8. COA-057309-2019

2318 Venable Street

STAFF REPORT

Rehabilitate an existing single-family attached residence.

Figure 7. Front door, basement level

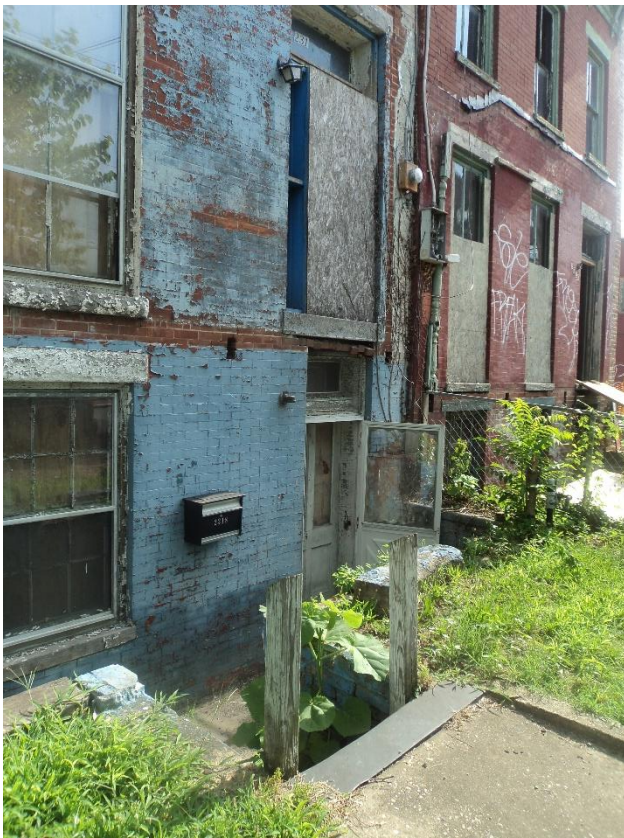
The applicant is also proposing to replace the basement-level door in the front with a slab

<p>door with a single light. This design does not match the existing wood door, however staff recognizes there may be safety and security concerns with the current design. <u>Staff recommends the basement-level door be replaced with a solid wood four-panel door, to match the existing design.</u></p> <p><u>As a material was not specified for the replacement doors, staff recommends final door specifications be submitted for administrative approval.</u></p>
Standards for Rehabilitation, pg. 59 #5	<i>Retain original windows including both functional and decorative elements such as frames, sash, muntins, glazing, sills, hood molds, paneled or decorated jambs and moldings, shutters and exterior blinds.</i>	The applicant seeks approval to replace all but one window and all exterior doors. Staff has analyzed the window and door survey provided and has determined that many of the windows are missing, beyond repair, or have been previously replaced. Based on the photographs submitted, staff has determined that the sashes of W12, the full-length window on the first story, can be repaired, though the frame may need replacement. Staff supports the restoration of this window.

- Revised elevations showing all chimneys be submitted to staff prior to the issuance of a building permit
- The existing front door transom be retained and a wood double front door be installed in the opening, to match the historic configuration
- The basement-level front door be replaced with a solid wood four-panel door, to match the existing design
- Windows W2, W3, W11, and W21, as indicated on the plans, be 6/6 to match the historic light configuration and have true or simulated divided lights with interior and exterior muntins and a spacer bar between the glass
- Window W11, as indicated on the plans, not be in-filled and the existing window dimensions be
